### Comments on (LWP 2006) Addendum to the Environmental Statement

by  
Richard Lindsay  
Head of Wildlife Conservation  
University of East London  
Romford Road  
London  
E15 4LZ

January 2007

**Figure 1.** Map of the new site-roads for the revised Lewis wind farm proposal.

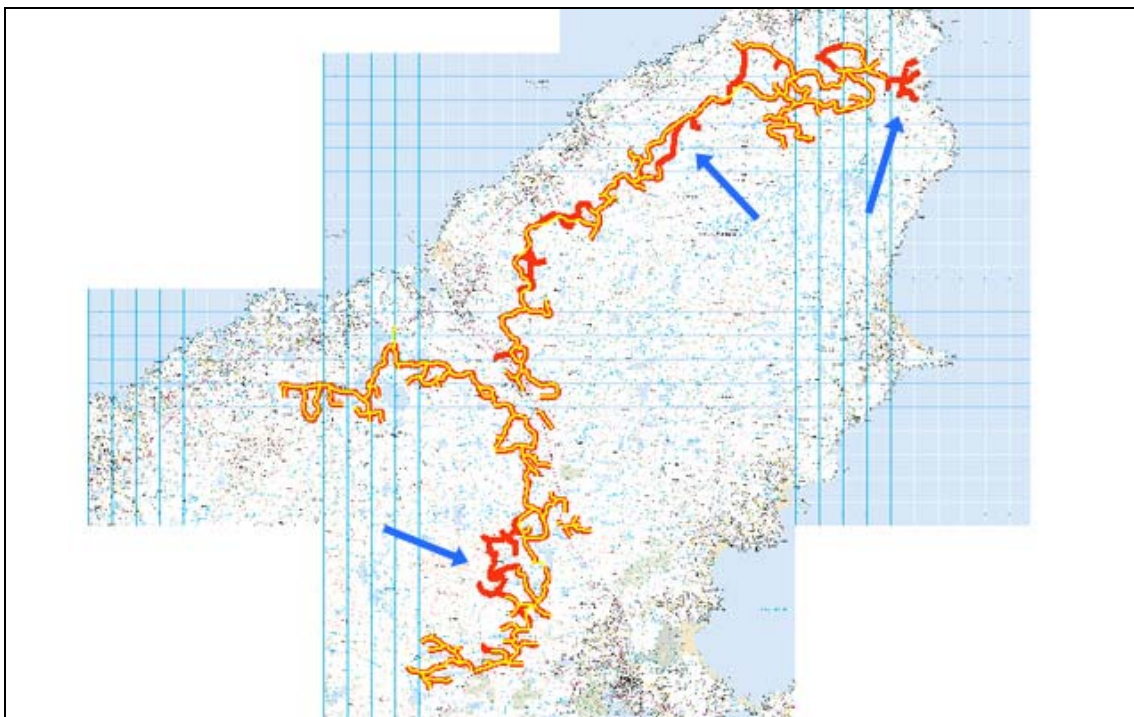
- 2.3 The development follows essentially the same routes as before (see Figure 1), albeit over a reduced total area (see Figure 2), with the result that ‘floating roads’ are still proposed for some 70% of the total road length. This is an enormous proportion of road infrastructure to be using for a construction technique that is relatively untested. Indeed not only is evidence available to show that such roads do not behave as predicted by the developers, but the construction technique described in the ES makes no reference to normal engineering practice on such soils, as will be discussed later.

**Figure 3.** Area indicated by LWP (2004) ES as NVC type H10b (dry heath). Arrows point to the abundance of common cotton grass (*Eriophorum angustifolium*) – a defining species for bog, rather than heath, communities - within the hagg-top vegetation.

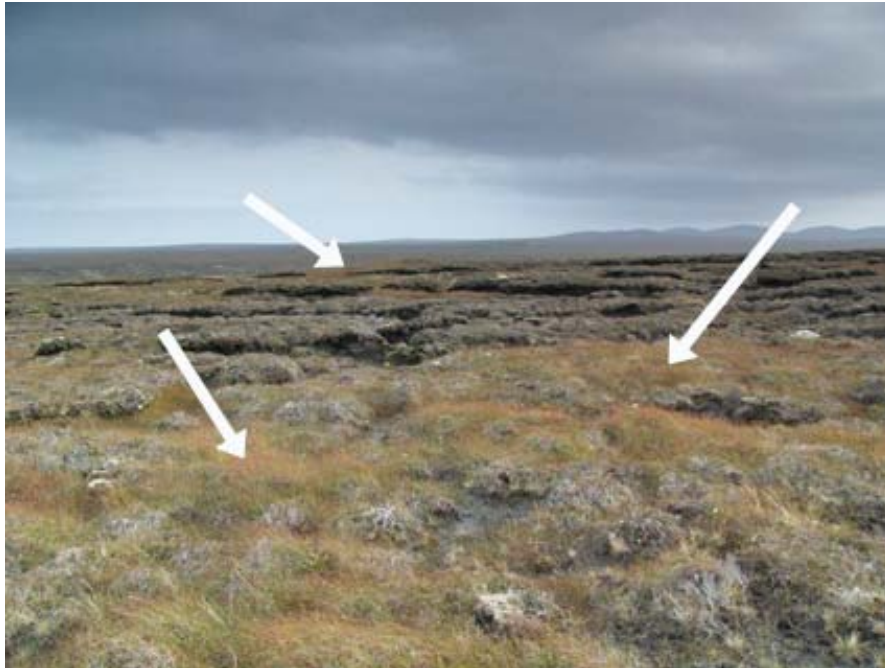
- 4.6 Common cotton grass is one of the key species differentiating bog peat systems from other habitat types. Dry heath is characterised by the absence of cotton grass (see Rodwell 1991). The extent of cotton grass in Figure 3 makes it quite clear that, even on most of the hagg tops, the vegetation is still essentially a mire (peatland) vegetation rather than a heath community. Widespread use of H10b on deep peat, as used by the mapping process of the LWP (2004) ES, would therefore still seem to be unjustified and inappropriate despite the extra justification put forward by the LWP (2006) Addendum. The assignment of blanket bog habitat to a dry heath vegetation type does not fit with the nature of the species assemblage, and distorts the

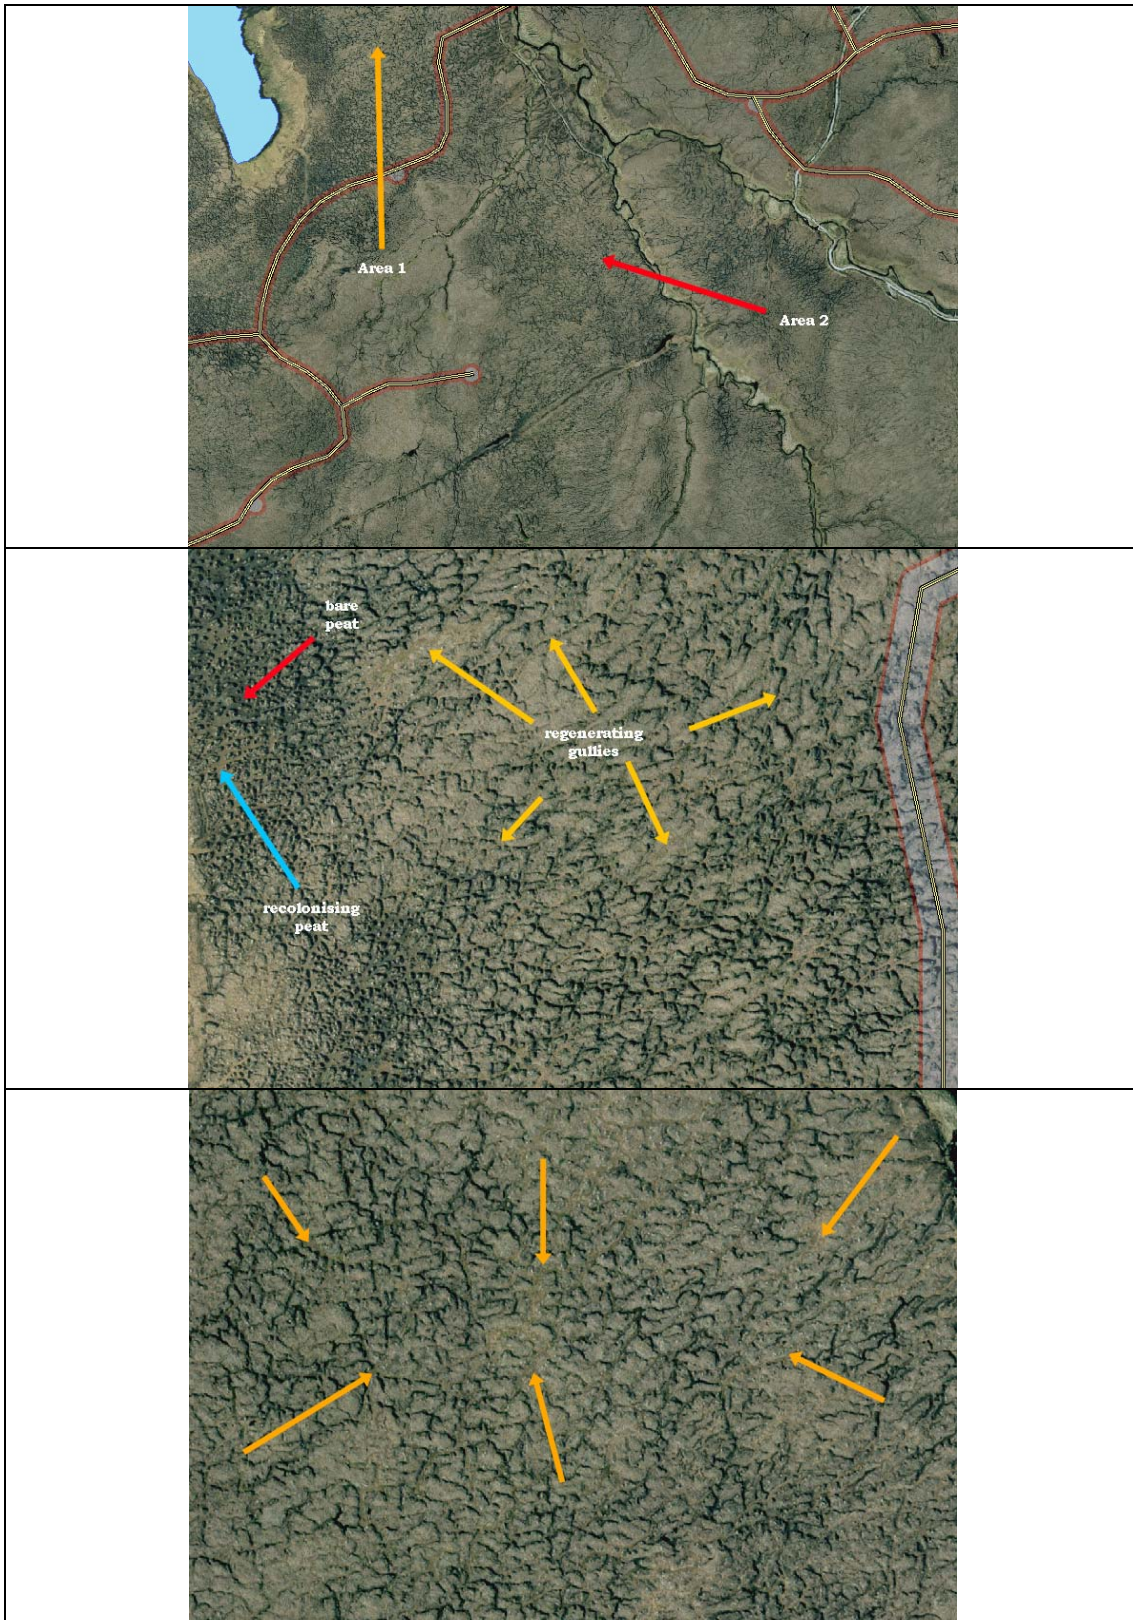
- 5.3 The scale of recovery can perhaps best be appreciated with reference to colour aerial photographs (see Figure 4), where the pale chestnut of cotton grass and paler shades of *Sphagnum* can be seen to dominate the network of erosion gullies.

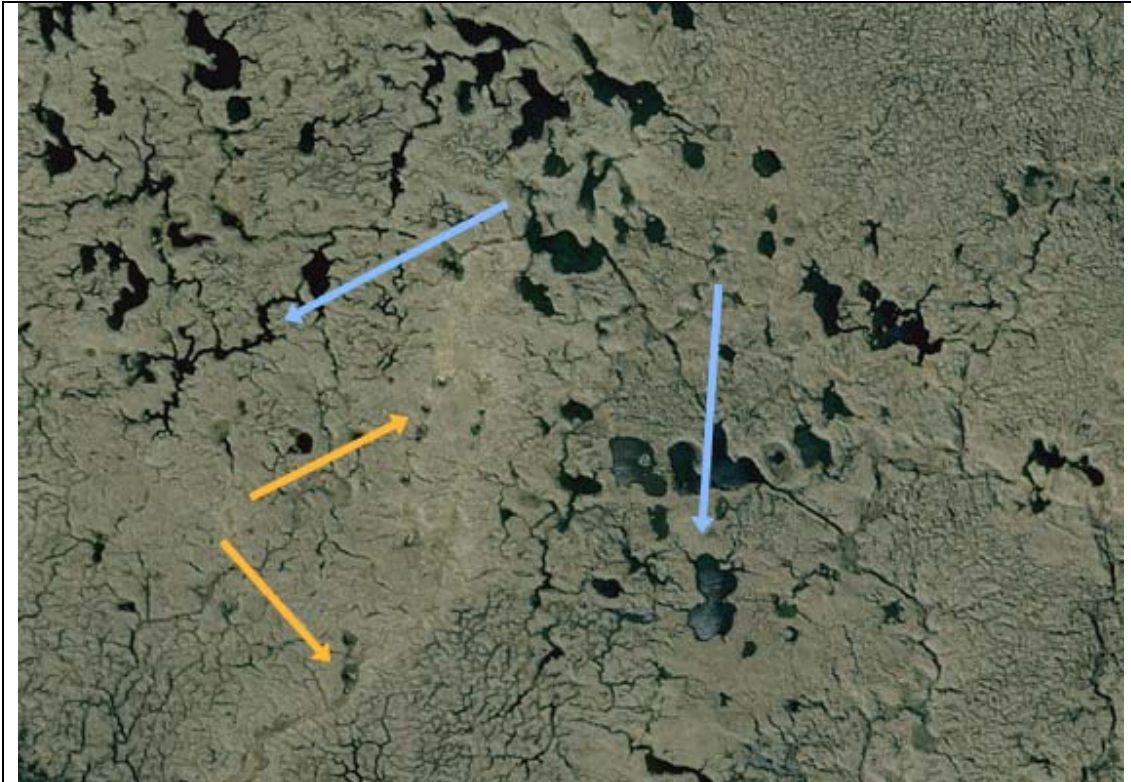
- 6.7 Indeed Figure 5 shows the same site as Plate 11B.24 of the LWP (2004) ES (referred to again in the LWP 2006 Addendum). In that document it is captioned as illustrating “Collapsed subterranean pipes as shallow depression lines and circular hollows, probably draining extensive watershed pool system (NB4255)”. It is actually located at NB4355, but what is evident even in Plate 11B.24 (and Figure 5) is that many of the large pools have high water levels – despite the immediate presence of this large peat pipe.

**Figure 11.** Line of proposed road (in red) close to Turbines G40 and G42. The road crosses an obvious line of sink holes (arrowed orange) and thus may compromise the associated peat pipe. The distance upslope (to top right) along the line of sink holes from the road to the large pools is 150m.

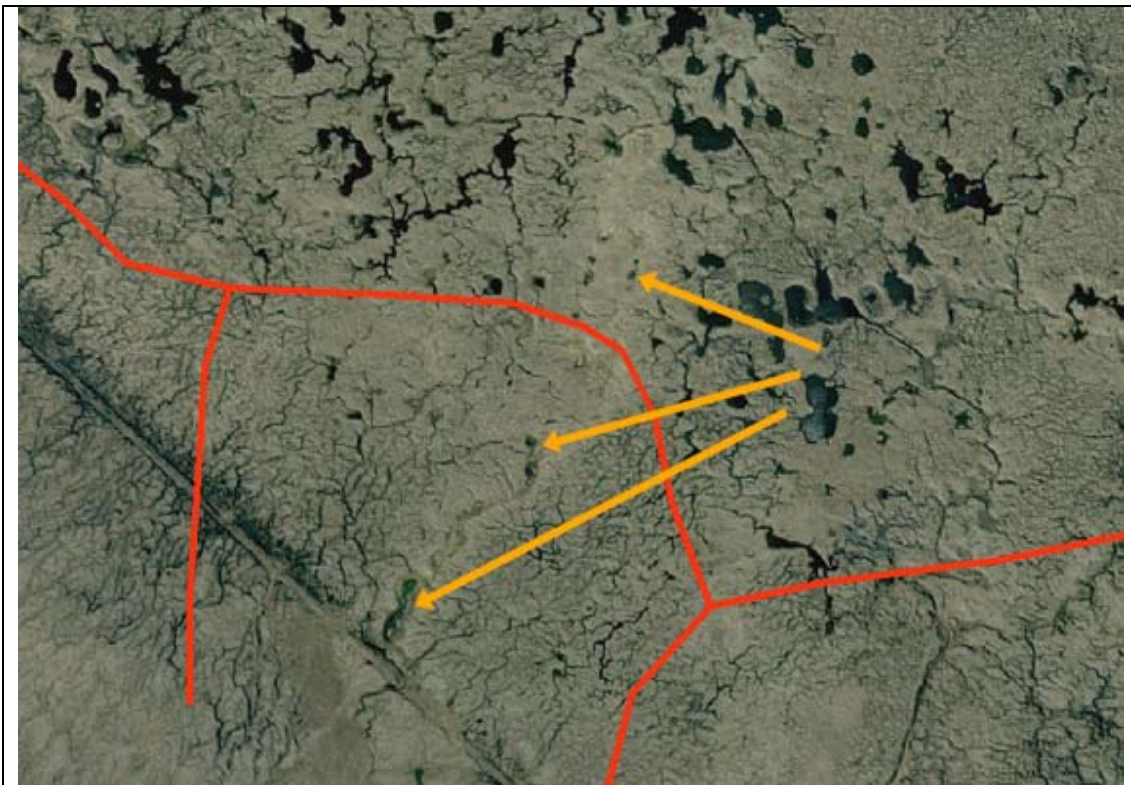
- 10.4 Taking another example of potentially complex impact interactions, Figure 11 shows a section of road near Turbines G40 and G42. The route of the road runs directly across what is obviously a sink hole/peat pipe complex. Where do the potential impacts extend to in this case? If the road is a floating road and progressively sinks (LWP 2006 Addendum, Appendix 11E indicates that this is likely) then what will be the hydrological implication for the peat associated with the length of this sink hole system? This system extends some 100m upslope into the pool system, and for several hundred metres downslope. What would be an appropriate zone of impact to define in this case? The 10m zone proposed by the (2006) Addendum is unlikely to be appropriate in this case.

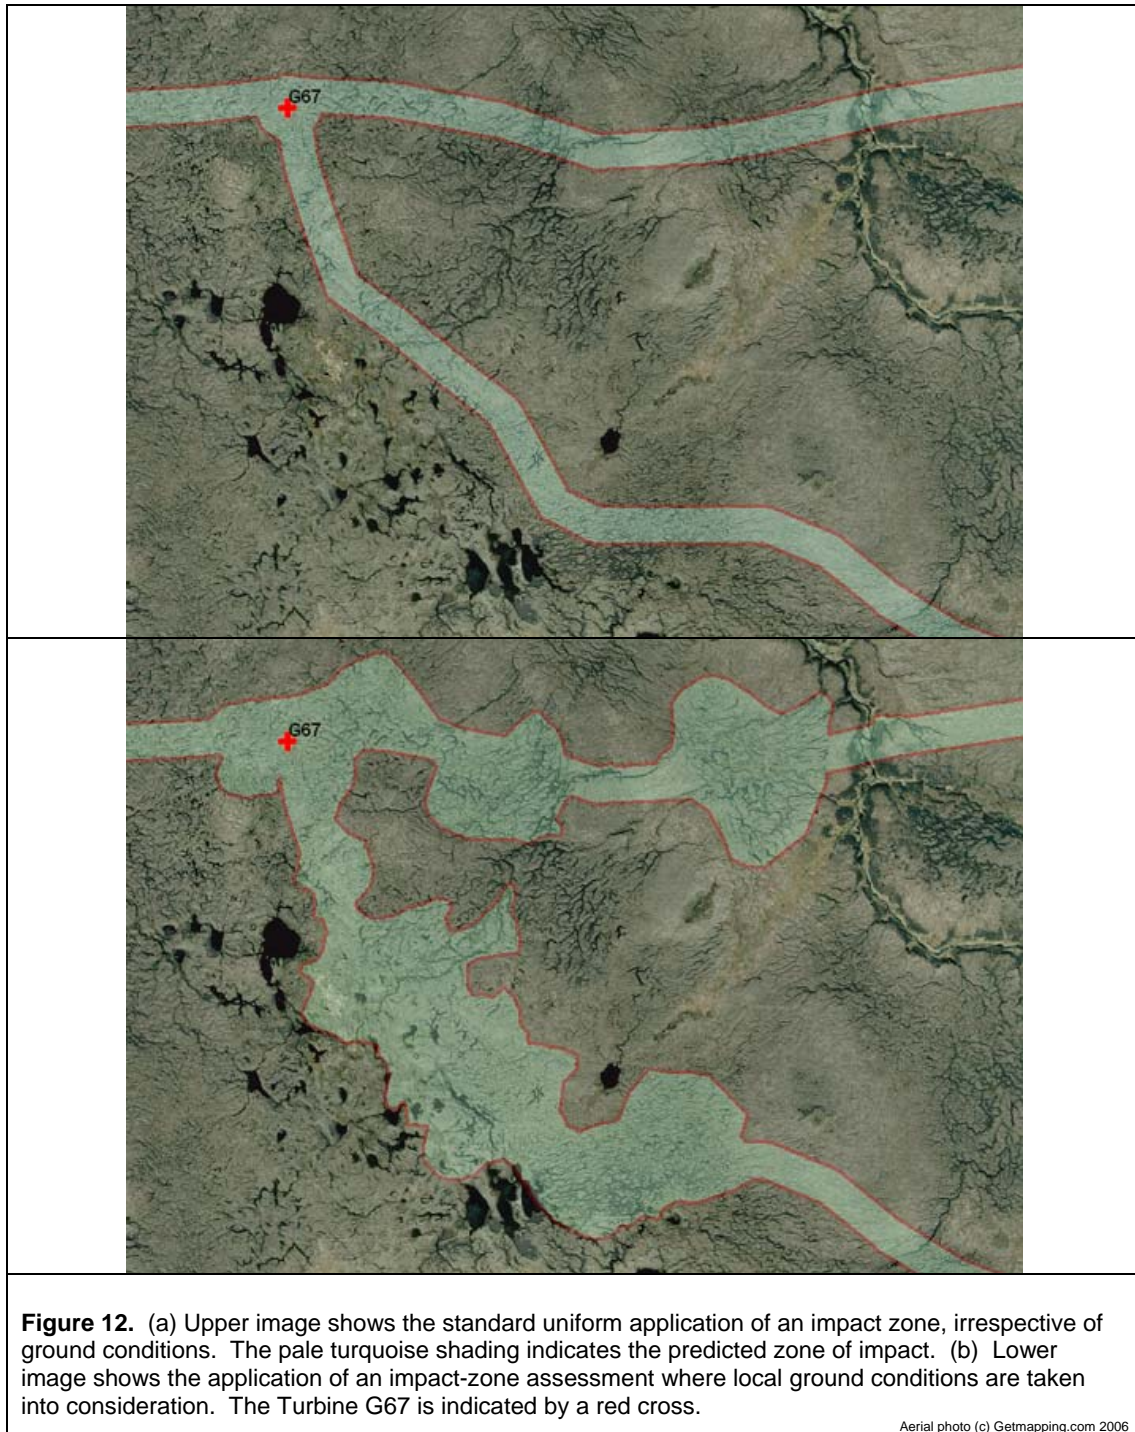
10.6 An example of the way in which the potential impact zone should be tailored to local conditions can be seen in Figure 12. This firstly shows the standard uniform impact zone applied by LWP (2006) Addendum. This uniform approach is then contrasted with an impact zone tailored to local ground conditions. The tailored boundary has been drawn up as an example only, and has thus been created by deciding specifically which areas of the erosion complex are most likely to be obviously and *directly* affected by the presence of the road. If the road passes through a bog pool, for example, it should be reasonable for even the most sceptical observer to accept that the pool will be in some way affected by this. Thus the tailored impact zone restricts itself to only the most obvious effects such as direct breach of a pool or cutting off the water supply to regenerating gullies. The tailored boundary, being only an example, does not attempt to incorporate possible indirect or secondary impacts.

10.7 Thus in Figure 12, a number of features are taken to have some potential for fairly obvious and potentially significant impacts - impacts on which all parties can probably agree: specifically, re-vegetating gullies immediately downslope from the road, pool areas directly affected, flat expanses of wet, regenerating bog vegetation. Elsewhere, on peat that is relatively smooth and gently sloping, the obvious and fairly immediate impacts are assumed to be no more than is suggested by the hydrological studies at Farr Windfarm. It should be fairly obvious that the resulting boundary begins to give a much more realistic
